CNL-17-049

Clinch River Nuclear Site
NRC Docket No. 52-047

Subject: Submittal of Supplemental Information Related to Site Safety Analysis Report
Figures in Support of Early Site Permit Application for Clinch River Nuclear Site

SUPPLEMENTAL INFORMATION REGARDING SITE SAFETY ANALYSIS REPORT FOR THE CLINCH RIVER NUCLEAR SITE

Figure 2.5.2-26. (Sheet 1 of 2) Map Showing the Eastern Tennessee Seismic Zone Geometry Defined by the U.S. Geological Survey

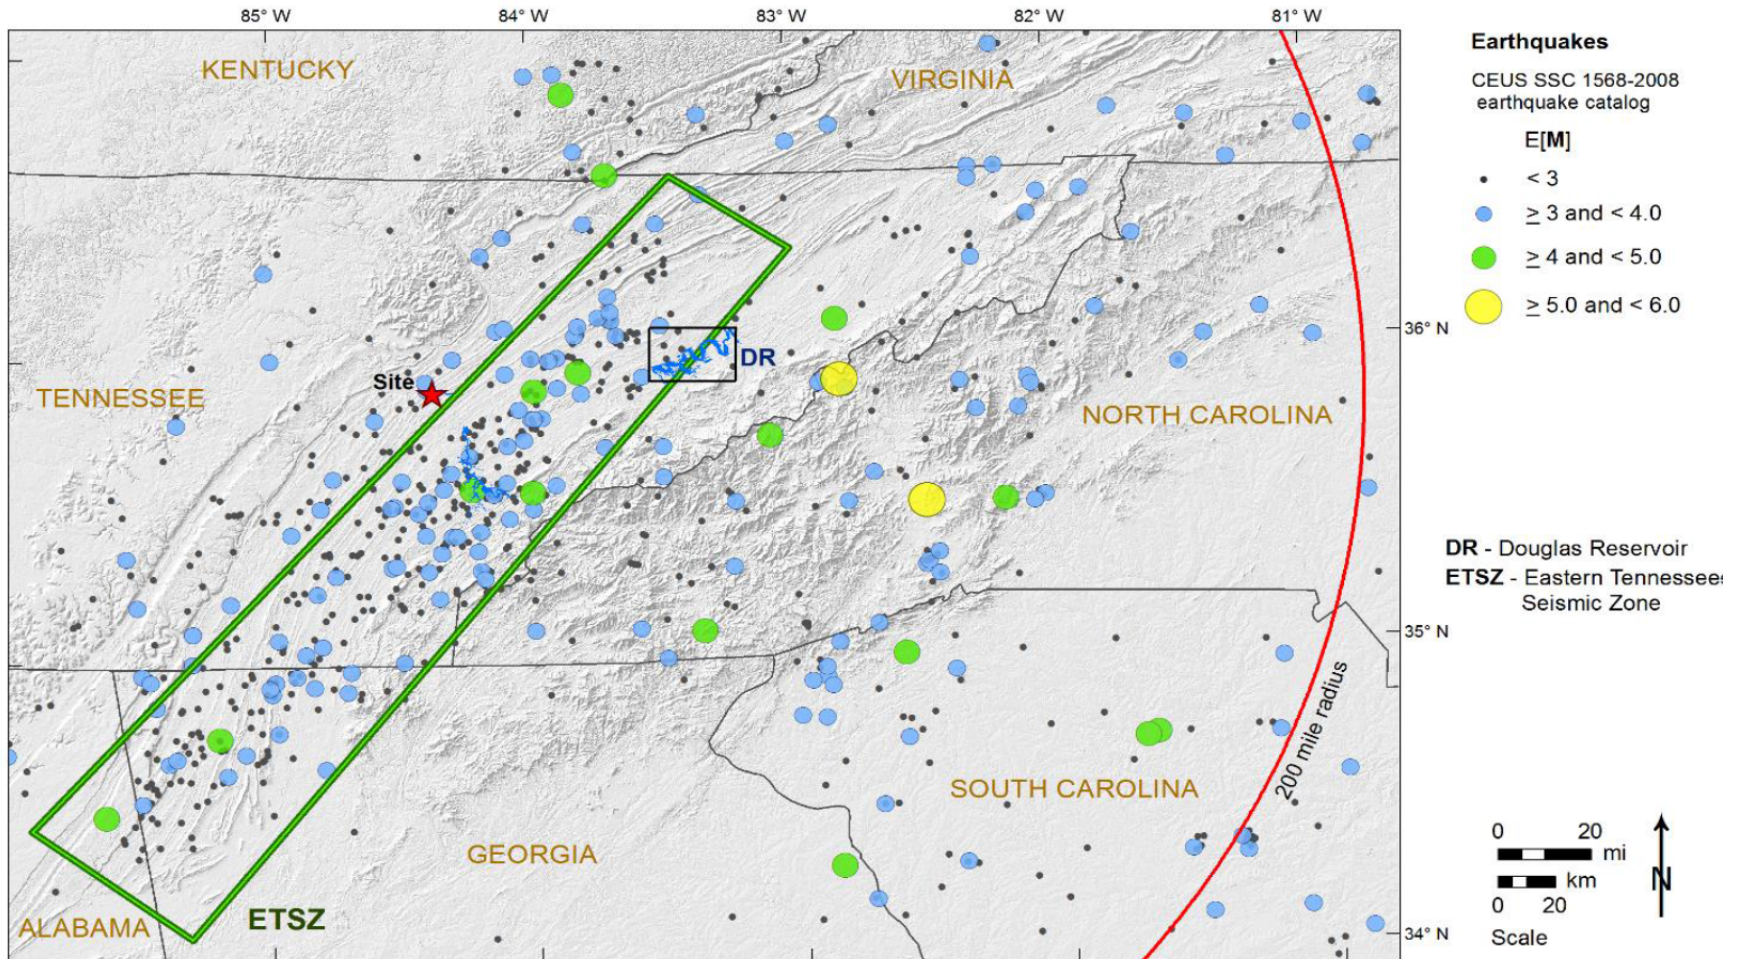
By letter dated May 12, 2016 (Reference 1), Tennessee Valley Authority (TVA) submitted an application for an early site permit for the Clinch River Nuclear (CRN) Site in Oak Ridge, TN. During a public meeting phone call held on February 21, 2017, the NRC requested that TVA consider providing supplemental information to provide a Site Safety Analysis Report (SSAR) figure similar to Figure 2.5.2-26, with expanded focus on the CRN Site relative to the East Tennessee Seismic Zone (ETSZ) and Douglas Reservoir.

To address the clarification requested by the NRC, SSAR Figure 2.5.2-26 (Sheet 1 of 2) is being revised and Figure 2.5.2-26 (Sheet 2 of 2) is being added to the ESPA. Reference to SSAR Figure 2.5.2-26 is being inserted in SSAR Subsection 2.5.3.2.6. Markups reflecting the proposed changes to the SSAR subsection and the SSAR figures are included in this enclosure.

Figure 2.5.1-65. (Sheet 1 of 2) Structure Contour Map of Shear Fracture Zones and Associated Profile

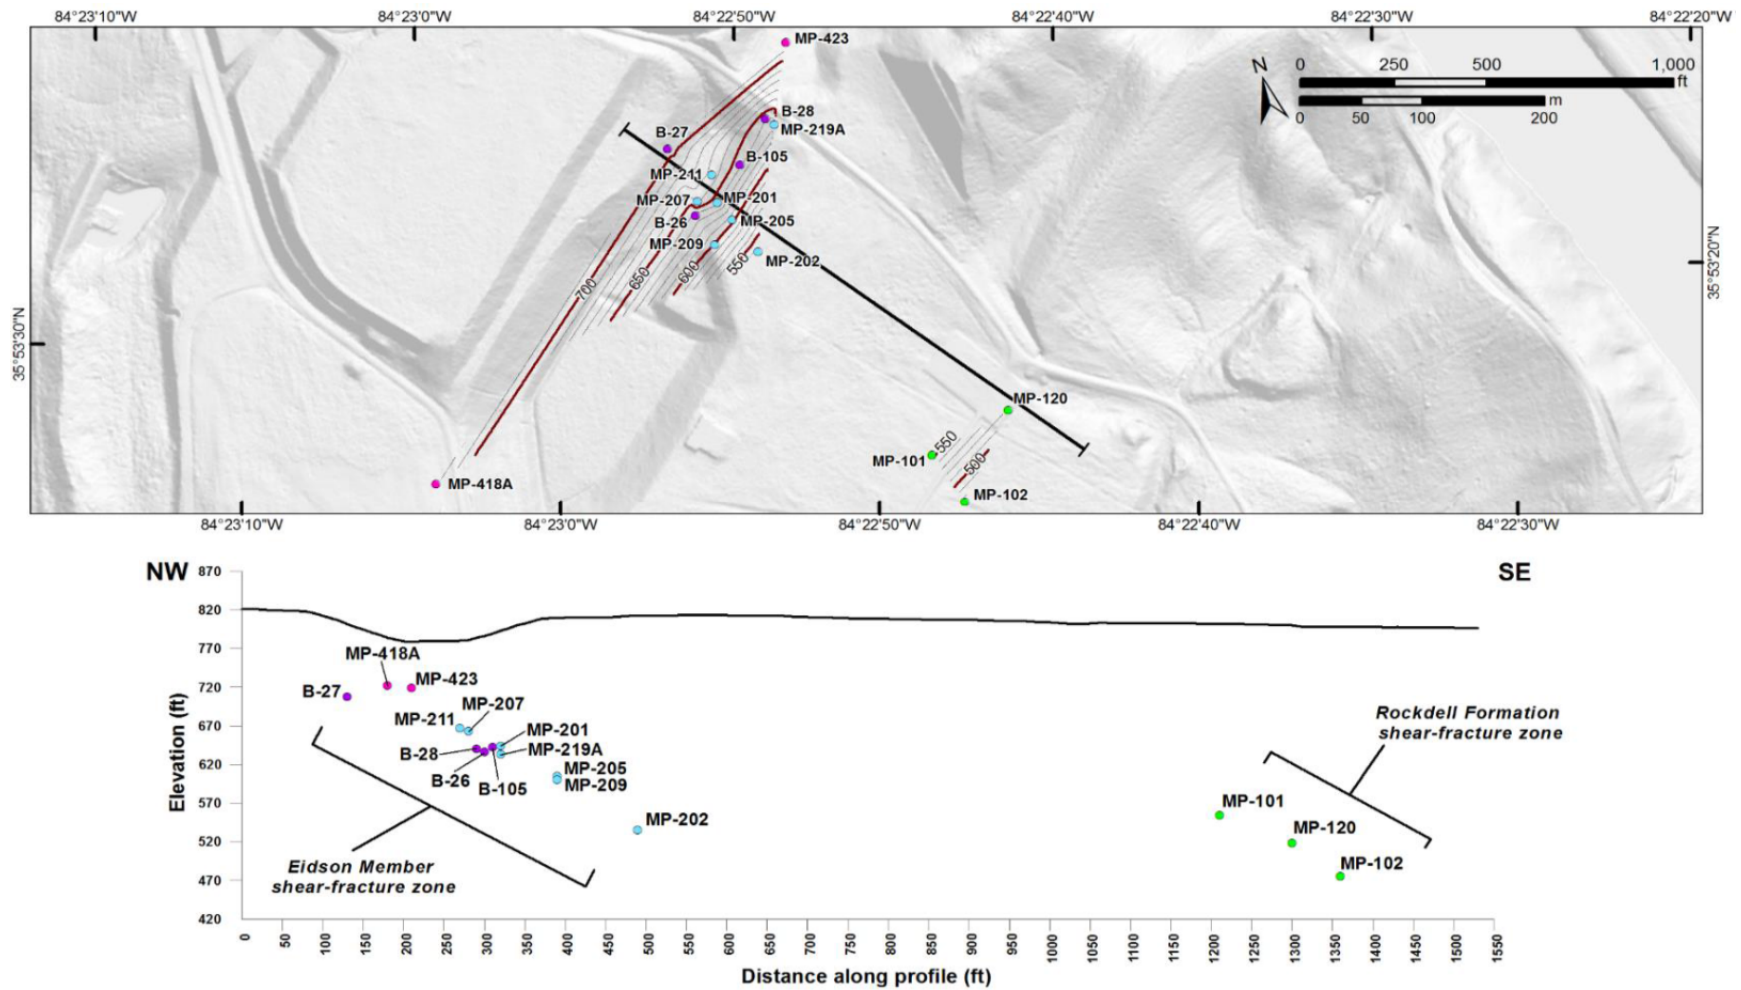
In addition, the numbers in parentheses shown on SSAR Figure 2.5.1-65, Sheet 1 of 2 (provided by Reference 2), were discussed during the public meeting phone call. The number in parentheses represent the apparent thickness of the shear-fracture zone encountered in boreholes. NRC staff requested clarification of the parenthetical values in SSAR Figure 2.5.1-65, Sheet 1 of 2, compared with the apparent thickness values in SSAR Table 2.5.1-17.

To clarify the parenthetical values, the shear-fracture zone thickness values initially presented in SSAR Figure 2.5.1-65 (Sheet 1 of 2) will be removed, and that figure will be revised to refer to Reference 2.5.1-100 and the more detailed thickness values listed in SSAR Table 2.5.1-17. SSAR Figures 2.5.1-66 and 2.5.1-67 (provided by Reference 2) are derived from the shear-fracture zone thicknesses listed in SSAR Table 2.5.1-17, making the listing of thickness values on Figure 2.5.1-65 (Sheet 1 of 2) unnecessary. A copy of the modified SSAR figure is included in this enclosure.

See Table 2.5.1-17 for MP-Series boring data. B-series boring data from Reference 2.5.1-100.
Geometry of shear-fracture zones are shown on Figures 2.5.1-66 and 2.5.1-67.
